# TOWN OF PLAINFIELD DESIGN REVIEW COMMITTEE REPORT

**CASE NO.:** [DP-25-087](#): Radiant DC, Allpoints 18

**REQUESTED ACTIONS:** Architectural and Site Design Review for a 100,833 (+/-) square foot data center.

Shown below are examples from page 11 of the [Exterior Finish Presentation](#).

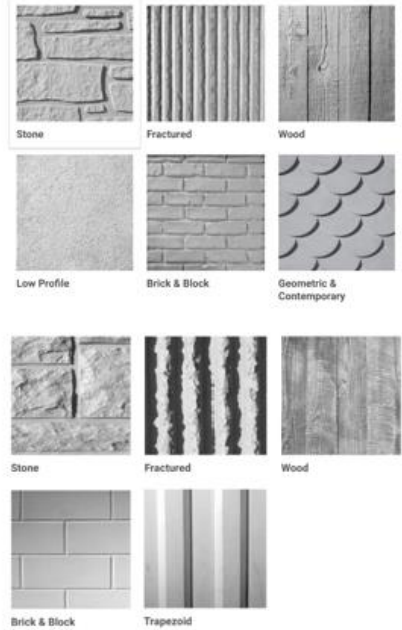
The applicant is proposing metal louvers on the roof to screen the mechanical units from all sides. While this definitely exceeds the ordinance requirement for line-of-sight compliance, it does pose a question as far as material classification. It does not appear to be an “exposed fastener” or a “standing seam” type metal. This leaves “Flat non-ornamental or non-architectural” or “ornamental or architectural.”

The zoning ordinance refers the issue of classification to the Design Review Committee, as this is a board with development and design professionals. Therefore, Staff asks the Committee for an interpretation of the metal type.

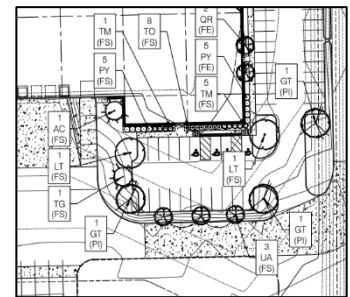
Staff had made a request to the applicants to present the landscape information in a specific way, but it appears that between the intervening holiday shortening the work time between the Project Review Meeting and the resubmittal date as well as a lack of clarity within the request, the result wasn't quite what had been sought.

To the right is an example of what the Development Guide requests for the landscaping plan. This will allow Staff to review the plan for compliance.

Staff believes that the presentation issues can be resolved prior to the resubmittal for the Plan Commission and asks the DRC to review based upon plant content.
